Public Input No. 206-NFPA 800-2026 [Global Input]

The code provides criteria for fire protection measures, emergency response consideration, and hazard control methods applicable to all lifecycle stages of batteries, except applies to the manufacturing, storage, transportation, operation, and recycling or disposal of batteries.

Figure C.3.1 Coin Cell.

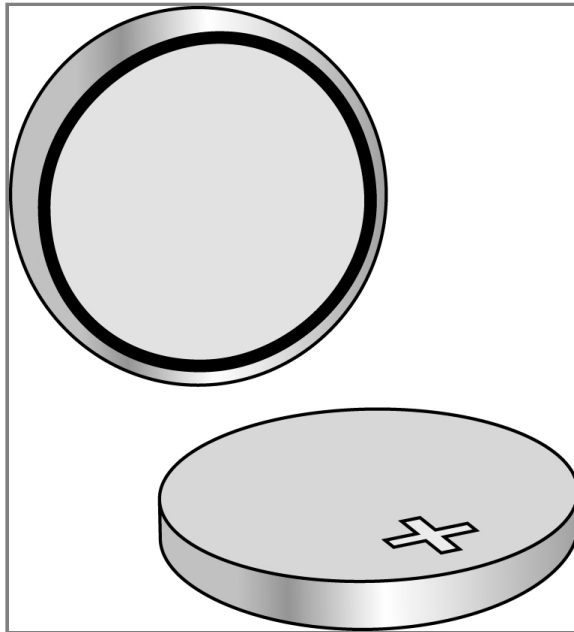
Coin cells or button cells are small disc shaped batteries used in lower powered devices with dimensions of 5–25 mm in diameter and 1-6mm in height, see Figure C.3.1. These cells are made of an anode, separator and cathode in layered form in a stainless-steel casing. The most used chemistry is lithium manganese oxide, zinc manganese oxide (alkaline) and silver oxide for primary applications providing 1.5 V and lithium ion for secondary rechargeable application providing 3 V. Chemistry is determined based on the application for required voltage and energy density. The size and shape of these cells can lead to ~~ingestion risks, that can~~ the possibility of ingestion that can cause internal burns and tissue damage if swallowed.

These coin cells are also used for testing new materials for their electrochemical performance, which is also called a half coin cell. The material to be tested is assembled against lithium metal with a separator in between and electrolyte filled. Even though it is not predictor of full cell performance, the isolated evaluation of the specific electrode provides repeatable and efficient data.

Figure C.3.3 Prismatic Cell.

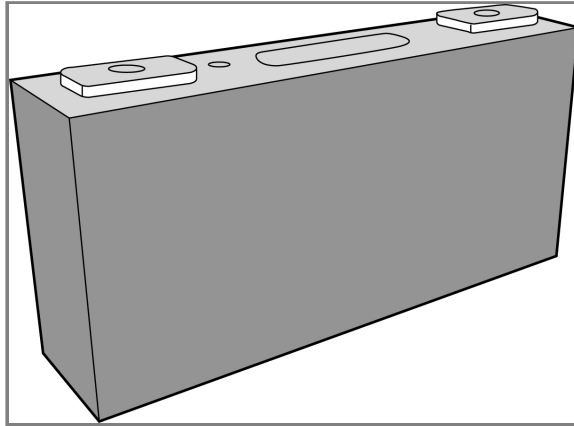
Prismatic cells consist of a flat electrode stack or a flattened jelly roll placed in a rectangular case. This case type makes them more space-efficient than cylindrical cells for pack design, see Figure C.3.3. They also typically have larger individual cell capacities than cylindrical cells. In prismatic cells it is harder to manage swelling, and an internal heat gradient is possible in large cells. For reactive metal chemistries, the larger cell volume increases stored energy, and thus the size of a fire from an individual cell thermal runaway, as well as the ~~risk~~ possibility of propagation from that thermal runaway. A case rupture of a prismatic cell can eject or spill a significant amount of electrolyte.
